## Product/Process Change Notice (PCN)

PCN #: PCN\_ConCARD\_20180226

Product Affected: P/N 693021010811

#### BEFORE: Normally open

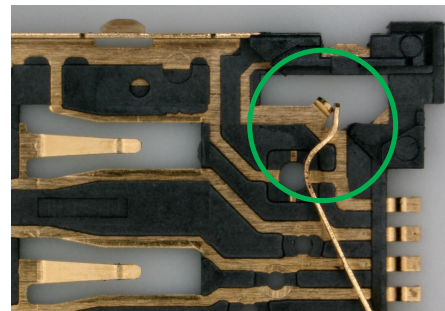
In order to enhance the product reliability, Würth Elektronik redesigned card detection feature on P/N 693021010811 with no change in layout or pin assignment.

#### AFTER: Normally closed

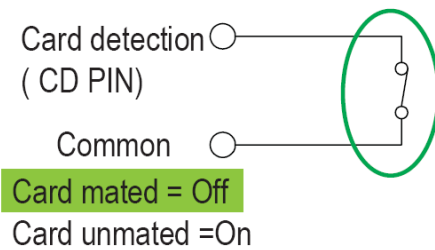
MicroSim card will come in contact with the elastic blade and open the card detection circuit. This solution is chosen in order to suppress the randomness of the pin targeting from previous design.

### LAYOUT & PIN ASSIGNMENT REMAINS THE SAME
